## Reviewer 1

The comments of Reviewer 1, along with our responses to each comment, are included below:

“This work presents a boundary optimal control strategy for axial tubular reactors with first-order irreversible chemical reaction incorporating a delayed recycle stream. The mathematical description takes the form of a system of coupled parabolic and hyperbolic PDEs. An infinite-dimensional approach is applied to derive a linear quadratic regulator with and without observer. Numerical studies show that the proposed controller is able to stabilize the system. The manuscript is clear and well written and addresses a challenging control problem in chemical engineering. The following comments and suggestions may improve the presentation so that it is considered for publication.”

Figure 1: Concentration profile along the recycle stream

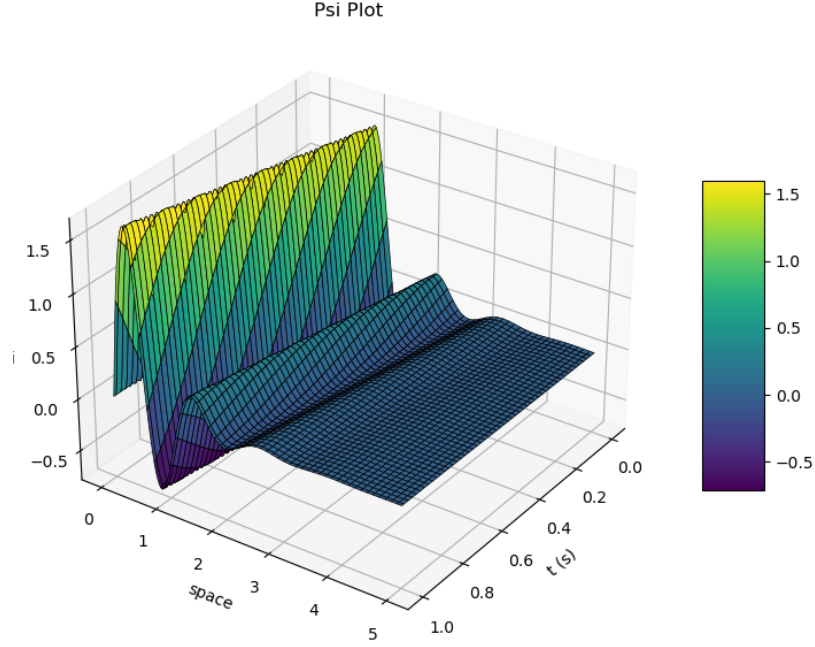
6. Page 7 - " $x_2(\zeta, t)$  is introduced as a new state variable to account for the concentration along the recycle stream"

- Why is  $x_2$  a function of  $\zeta$  ? How does  $x_2$  change across the recycle? What kind of law does it follow? To me, it seems like  $x_2$  only changes with respect to time

**Authors Reply:**

We have assumed that along the recycle stream, the flow of the reactant belongs to the class of pure transport PDEs. This is the case when diffusion term and reaction term become negligible compared to the convective term, and the state variable  $x_2$  is merely being transported along the recycle stream. Nevertheless, this still means that  $x_2$  is a function of  $\zeta$  and  $t$ . Concentration profile along the recycle stream has not been presented in the original submission as we believe it is not the focus of this work. However, for the reviewer's reference, it is included here in the response as shown in Fig. 1.

Figure 2: Axial tubular reactor with recycle stream.

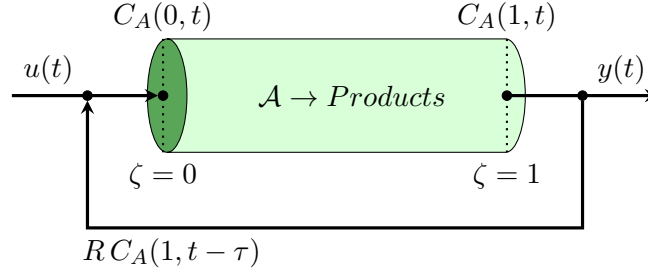
11. Page 18 - unstable dynamics of the model

- Why is the zero-input response considered unstable? Is it a qualitatively assessment? What is the physical meaning of Figure 9?

We appreciate the reviewer's thoughtful questions regarding the zero-input response and its interpretation. As mentioned previously, the original submission focused on the broader goals of the study, offering a concise explanation of the proposed model. However, based on the reviewers' feedback, we recognized the need to address potential misunderstandings caused by this brevity. To address this query comprehensively, we aim to clarify the modeling approach by outlining the modeling steps and the reasoning behind the chosen framework here in the reply, as they are critical for understanding the observed instability and its implications. In addition, we have also updated the manuscript to provide a more detailed and general explanation of the model. These revisions ensure that the manuscript presents a clearer and more comprehensive framework while preserving the original model's intent and structure.

For the axial dispersion tubular reactor presented in Fig. 2, the molar balance equation may be written for the reactant concentration,  $C_A$ , as follows:

While no isothermal reactor can technically be exponentially unstable due to the finite amount of reactant available, such systems can be unstable in the vicinity of the steady state, meaning that a deviation from the steady state may draw the states of the system to a different steady state, resulting in completely different model dynamics than the one used to design and control the system for optimal operation.

Performing the eigenvalue analysis of the system, we have observed that a system may have unstable steady-state only when the reaction term coefficient  $-\frac{\partial r(C_A)}{\partial C_A}$  is positive around a given steady-state. Though an uncommon scenario, this may happen in the case of autocatalytic reactions, enzyme-catalyzed reactions, reactions that incorporate inhibition mechanisms, etc. Although the proposed controller can also stabilize an already stable system in an optimal manner, a positive reaction term is intentionally selected to demonstrate the ability of the proposed controller to stabilize a system which is mathematically unstable. We believe that such aspect of the controller has to be inspected within the general framework of the controller proposed in this work as it becomes more significant when the work is extended to more complex systems where instability becomes a common issue.

As a result, the zero-input response is considered unstable due to the positive reaction term in the model. Figure 9 illustrates the unstable dynamics of the linearized model in the vicinity of the steady-state in the absence of control input; with the qualitative assessment that a deviation from the steady state may draw the system to a different steady state, resulting in completely different model dynamics than the one used to design and control the system for optimal operation. The manuscript has been updated to include more detailed explanation in this regard.
